**Re: Concept Plan Application 10\_0193, SIMTA Intermodal Freight Moorebank**

Council's submissions consists of this letter and the attached peer review by Cardno. The following comments are provided to supplement the Peer Review document;

**Figure 13 – Future Road Link**

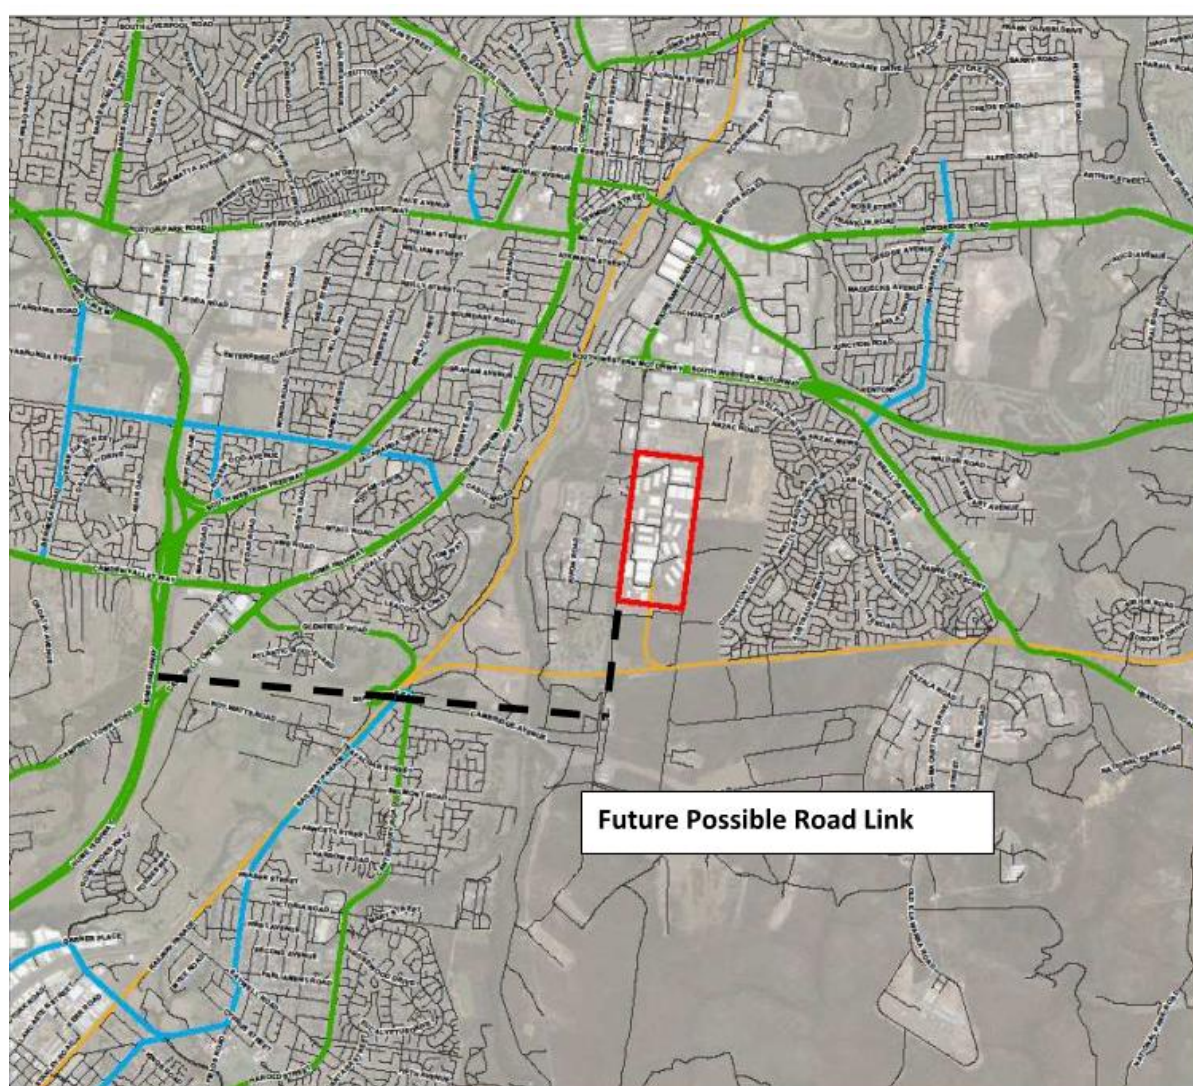
SIMTA's proposal can only obtain access from Moorebank Ave. The traffic models have not included a **risk assessment** of the future 2031 road network. For example only one major access road has been assumed for access to the SIMTA site and this is through Moorebank Avenue from the north. A serious accident on this section of Moorebank Avenue would prevent or severely restrict all cars and trucks from entering and leaving the site.

There is the possibility of accessing the SIMTA site from Moorebank Avenue south of the site (see **Figure 13**). This would require the construction of a new road link between the Hume Highway and Moorebank Avenue via Cambridge Avenue. LCC has set aside an undeveloped corridor of land for such a road link. From the traffic results produced, the need for this road link should have been tested to determine whether it would have increased traffic capacity to the site. This road link is however not considered in the SIMTA's assessment.

**Figure 14 – Recommended Sound Power Levels ( $L_{Aeq}$ ) to meet Daytime Project Specific Noise Level at the Nearest Residences ( $dBA/100m^2$ )**

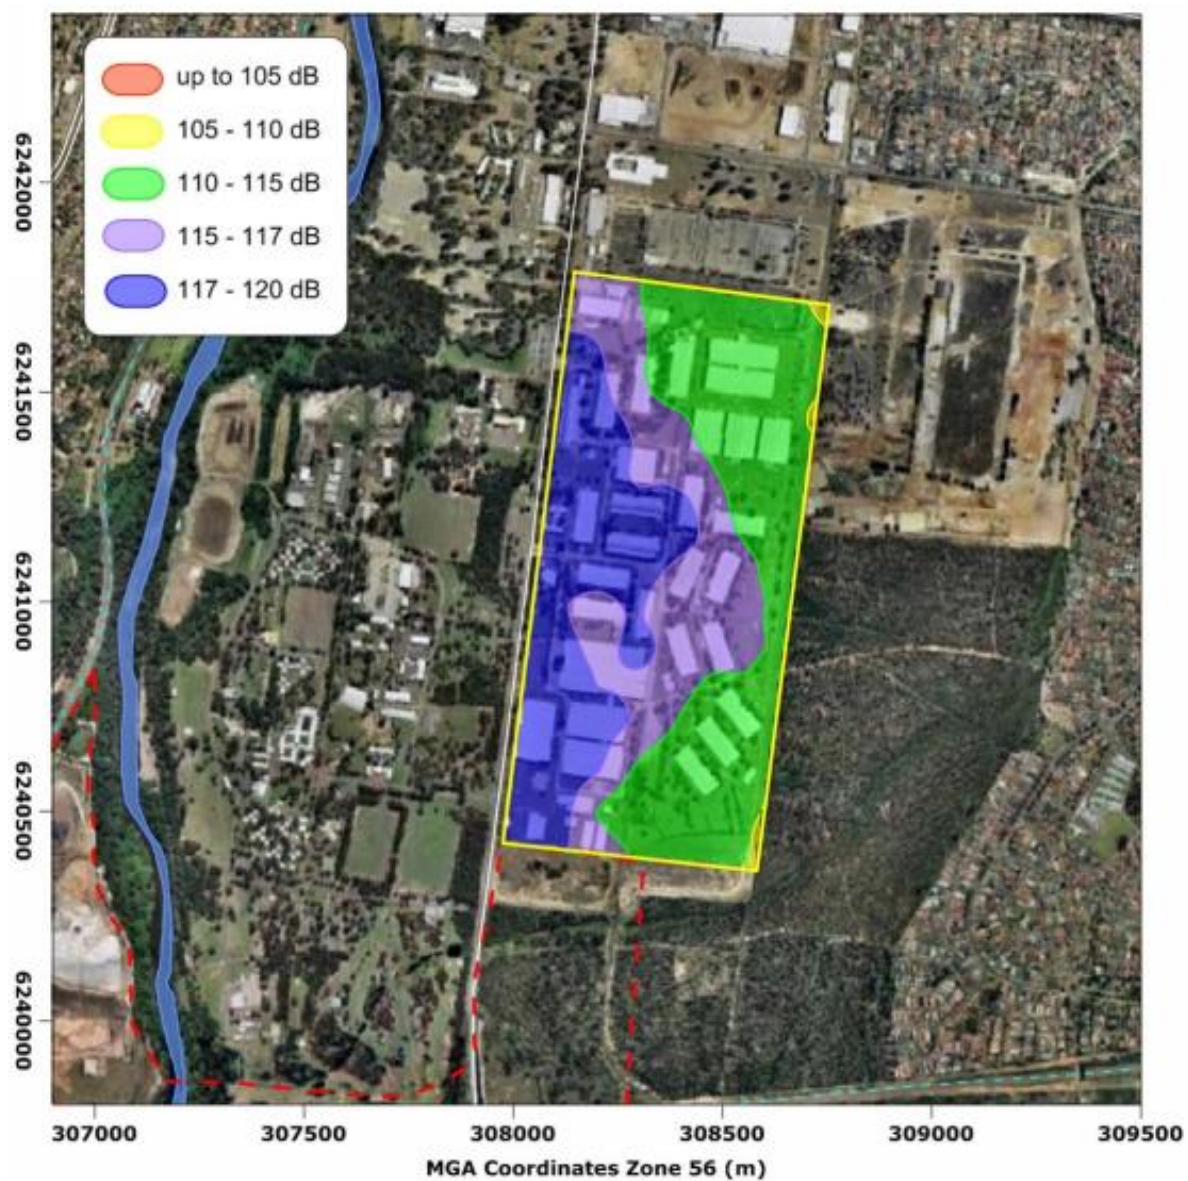
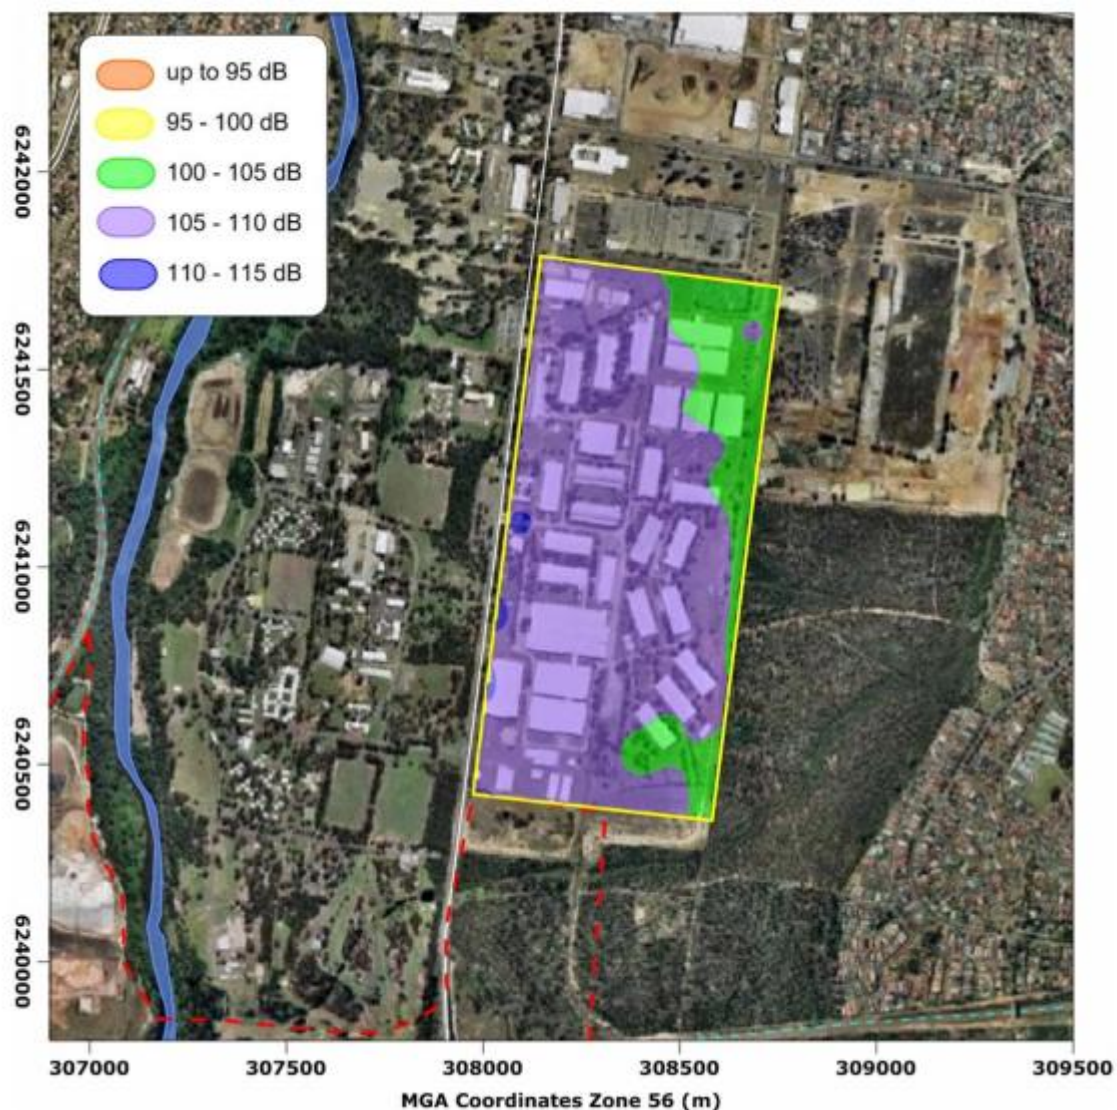
The acoustic assessment has been carried out by determining limit sound power levels across the site (see **Figures 14 and 15** above), in order to comply with the site specific operating noise criteria (obtained from the NSW Industrial Noise Policy – INP), including sleep disturbance at the nearest noise sensitive receivers. However, it is not clear where these noise levels have been calculated to, in order to provide site noise “limits” and if these levels are feasible, as there does not appear to be an agreed site plan for the site. Clarification is also required to confirm if the predicted levels are the aggregate of combined site operations, road and rail traffic on the site itself. Calculating noise levels in this manner would be consistent with a feasibility study, where limited information is available regarding site specific operations, placement of buildings etc. The proposed Concept Plan design has not been tested to demonstrate if these calculated noise levels are achievable on the site. It also does not provide any guidance to the future operators on how to manage and monitor the noise emission to these levels. Location of plant and equipment on site is critical for an acoustic assessment.

**Figure 17 – Indicative Precinct and Land Use Plan**

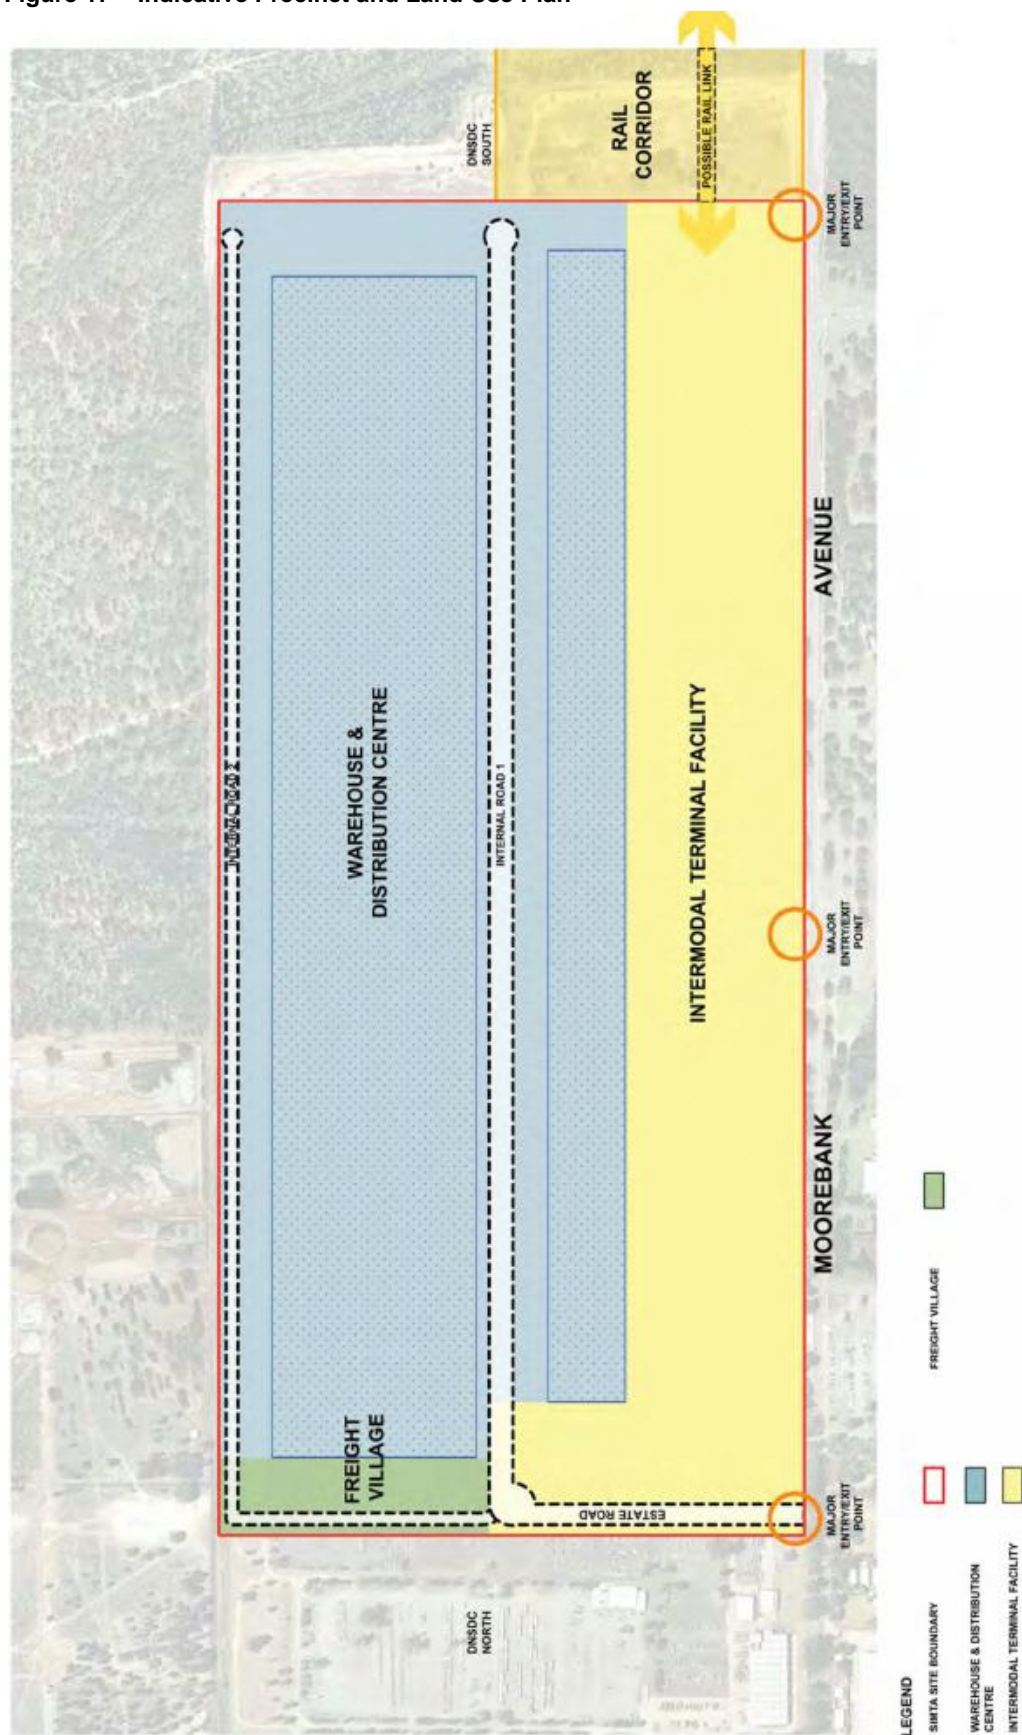
The report includes broad principles for achievement of high quality urban design but no drawn urban design or built form concept is included.

The Landscape Design report again includes principles for landscape design which incorporate landscape buffer zones around the site and broad avenue treatments. Typical building forms, character images and landscape treatments are included for warehousing, support areas and general industrial development (pg. 62-64 of the Urban Design Report). These are shown in the **Figures 18 – 22** below.

**Figure 28 - Forecast Demand with SIMTA & Eastern Creek**

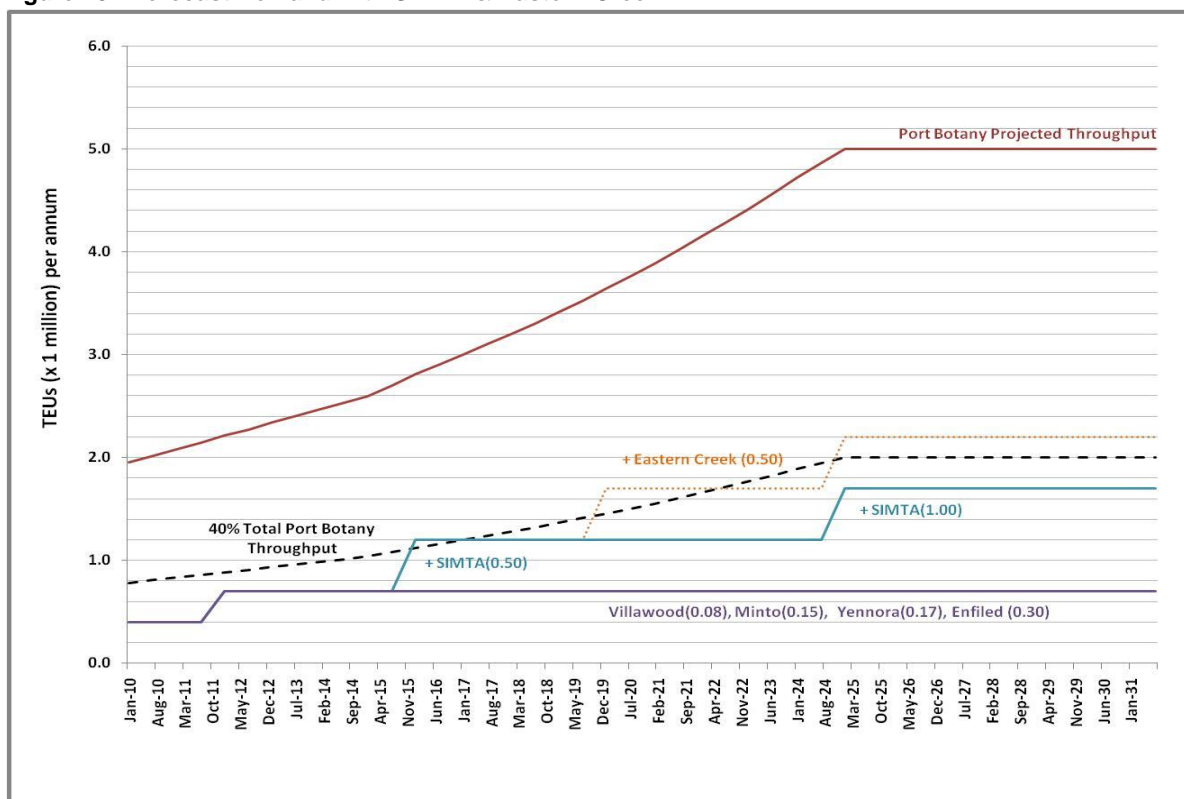
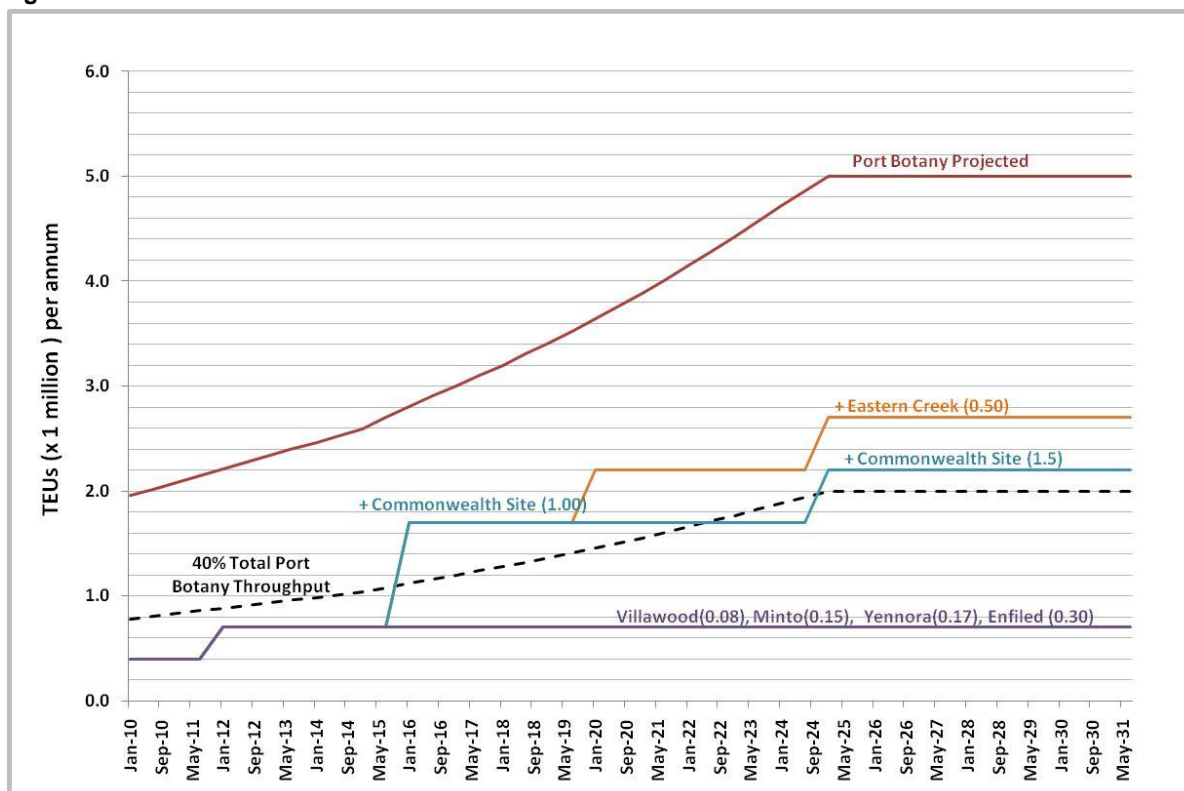
We found the following fundamental issues relating to the SIMTA's assessment:

- SIMTA has failed to include the planned but not approved IMTs into the consideration of its demand analysis. These include the adjoining Commonwealth Government's proposal, which will have a capacity for 1.5 million TEU per annum and the Eastern Creek proposal, which will have a capacity for approximately 0.5 million TEU per annum.
- Whilst Port Botany accounts for almost the entire volume of containerised import/export trade throughput in NSW. Most intermodal terminals service both local and interstate trades due to the ability to cover both markets once the infrastructure is established. However, the SIMTA's proposal has no mentioned of transfer to rail for inter-state or inter regional delivery, yet this option has not been ruled out.
- SIMTA's demand analysis is based on unpublished data that is impossible to verify.

**Figure 28** shows SIMTA starting in 2016 and reaching capacity by around 2025 on top of existing or future intermodal terminals. **Figure 28** analyses the timing proposed by the Moorebank Project Office in their Preliminary EA report and on their website. The Commonwealth Government's documents suggested a timing of mid 2017 to commence operation for the initial 1.0 million TEU, and ramp up to 1.5 million TEU by 2024.
